TO: Bob Exstrom, Town of Parker
FROM: Stacey Nerger, Senior Planner
DATE: April 23, 2024
SUBJECT: Parker Town Hall Amendment 3 Lot 1 – Site Plan
Review Comments 03

PARKER TOWN HALL EXEMPTION PLAN AMD3 L1

SITE PLAN SUBMITTAL

Parker Town Hall Expansion

SITE PLAN

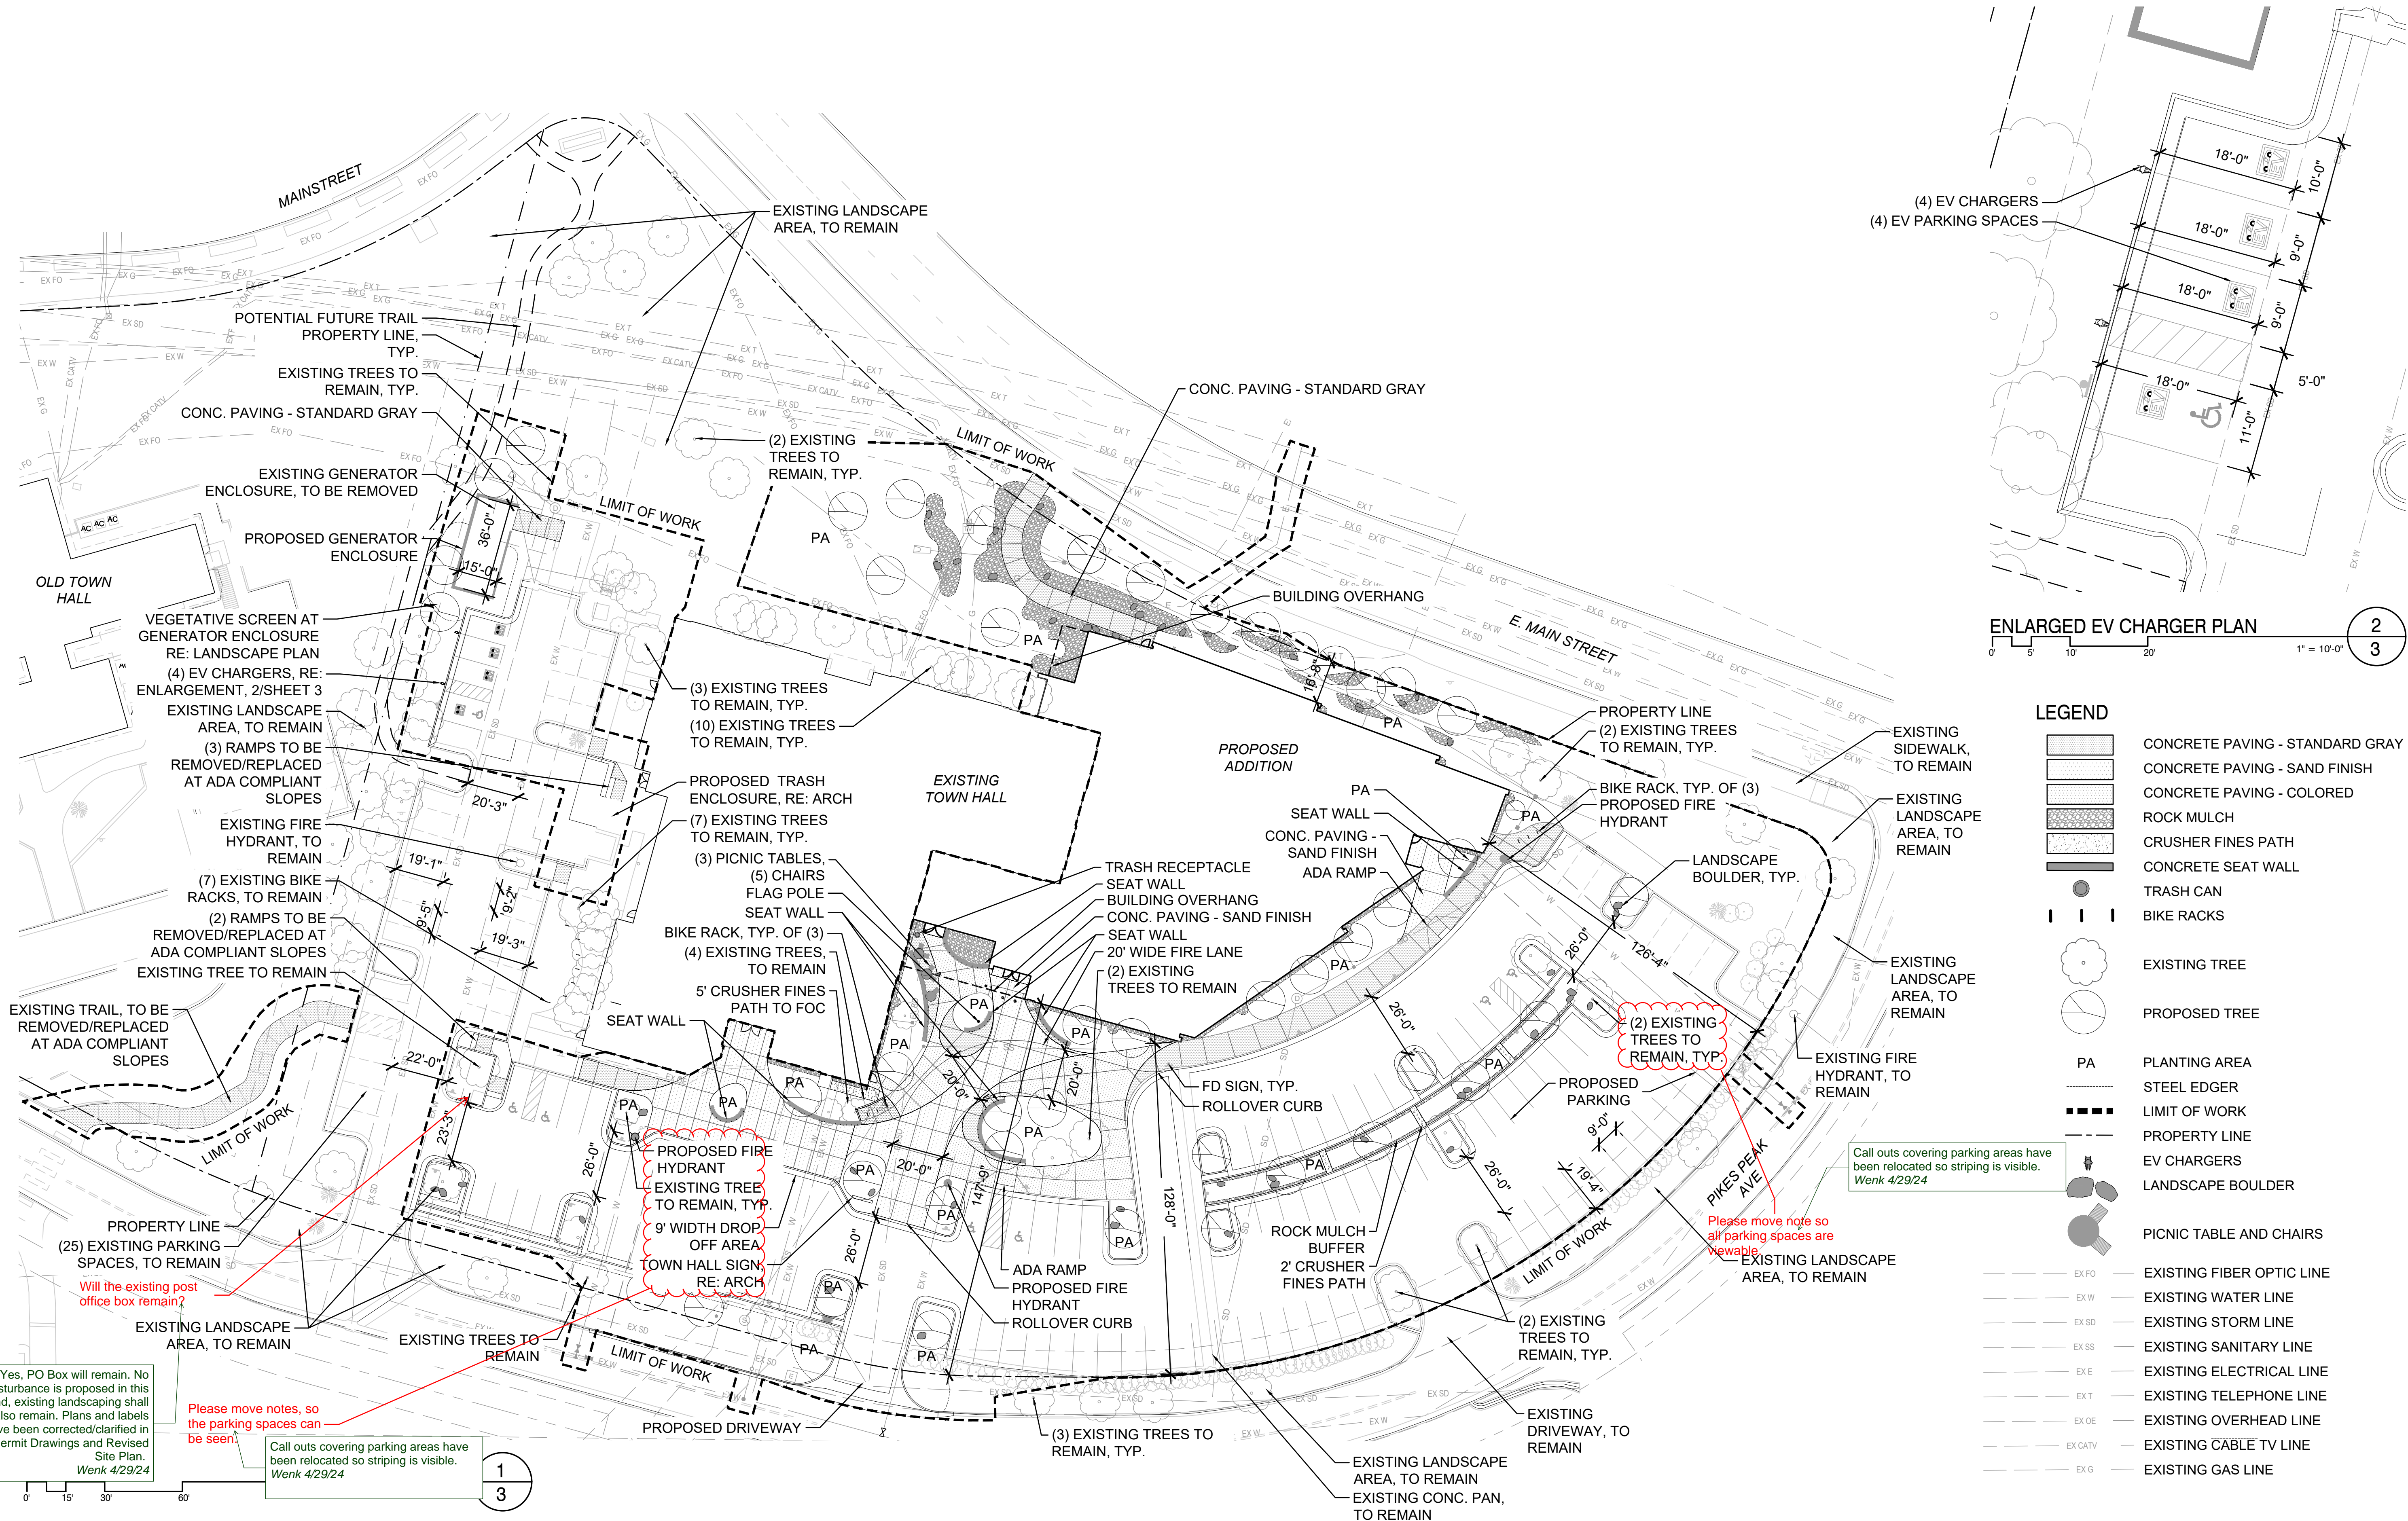
Add parking spaces adjacent to landscape islands. These spaces need to either be 10' in width or the island needs to include an 18" concrete step out strip. If you are using the 18" concrete strip, please add a note below table and leave as currently written.

Change this to be the actual parking spaces provided with EV chargers. Also, please remove these spaces from the typical parking spaces as the numbers don't work. Understand that there is a note to clarify, but it would be cleaner to just removed the EV spaces from the typical spaces.

TABLES HAVE BEEN UPDATED ON REVISED SHEETS

LANDSCAPE PLAN

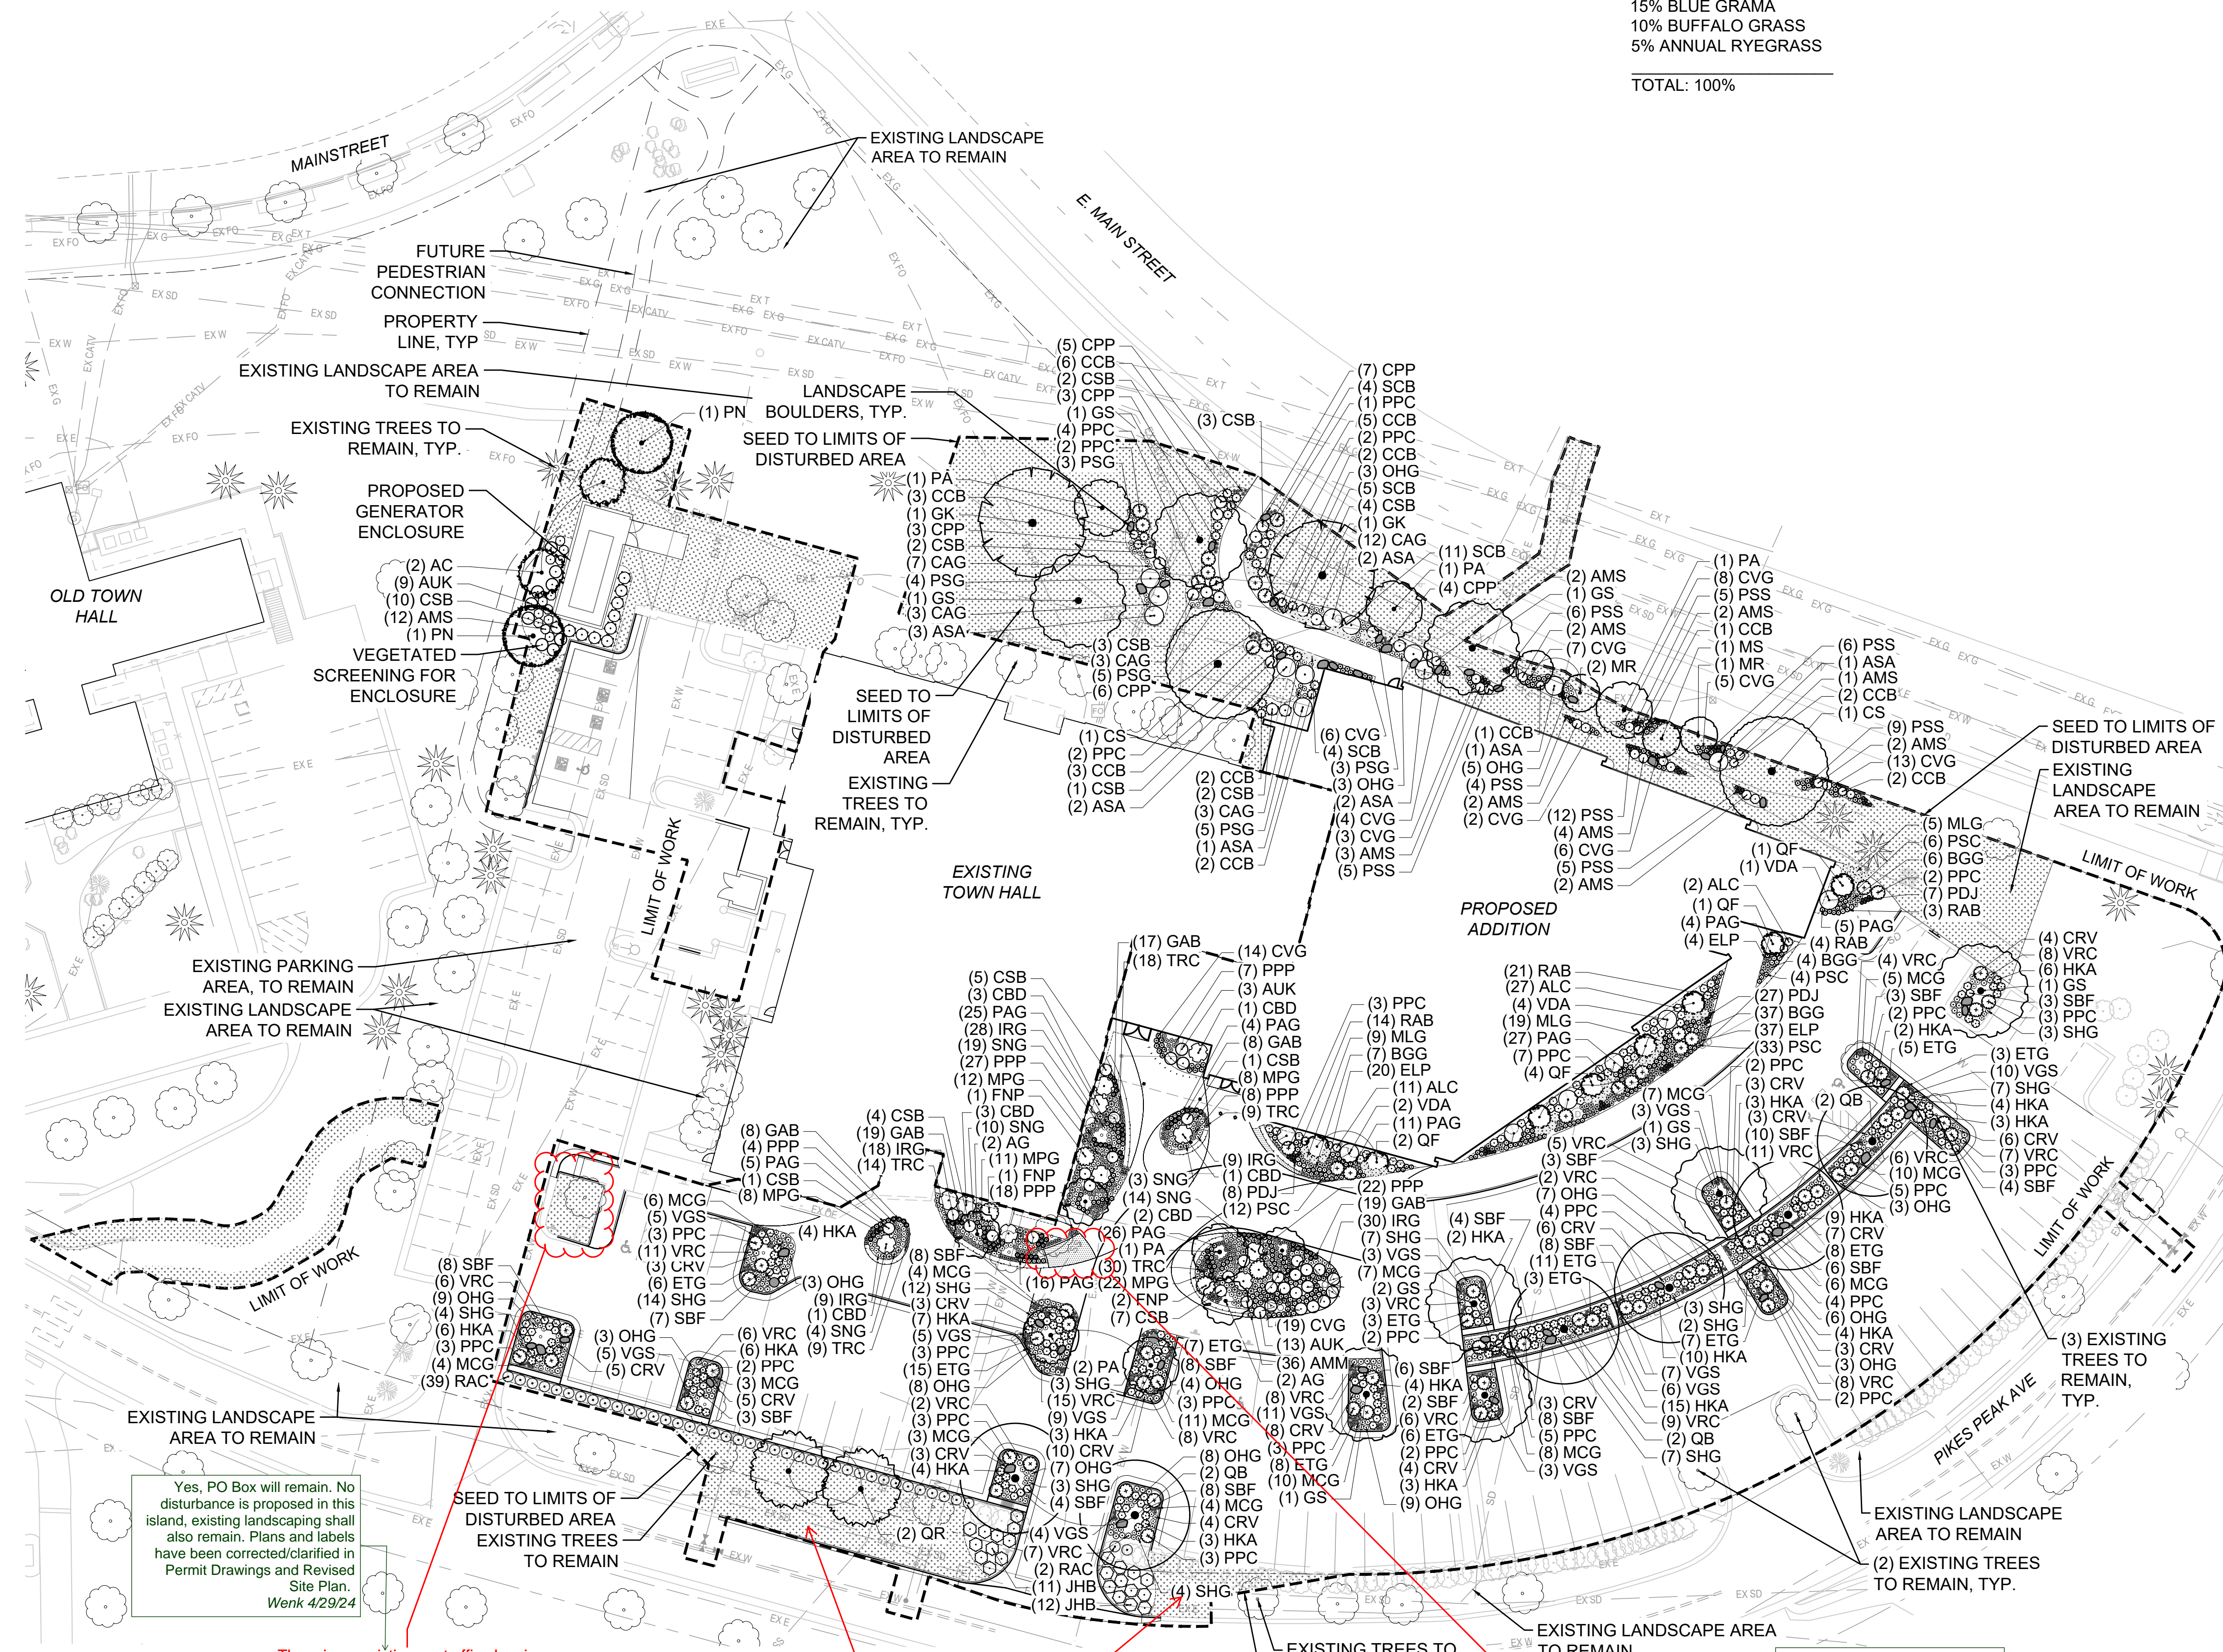
The only place I see this is the bike rack location. Is this correct? Is so, can this be changed to concrete?

There is an existing post office box in this location. Will it remain? If not, please fill in with additional shrubs.

I believe the existing groundcover within this area is turf grass. Filling in with native will most likely not work. Please verify.

Why crusher fines? Can this be changed to concrete?

Crusher fines are in the large parking lot median as cut through areas, and behind the bike racks for fire dept access, please see site plan. Bike rack area is concrete. Wenk 4/29/24

Yes, PO Box will remain. No disturbance is proposed in this island, existing landscaping shall also remain. Plans and labels have been corrected/clarified in Permit Drawings and Revised Site Plan. Wenk 4/29/24

Plans have been revised to include bluegrass sod/repair in kind to match adjacent/existing sod. Wenk 4/29/24

Bike parking area is concrete, please reference site plan. Planting plan has been revised for clarity. Wenk 4/29/24
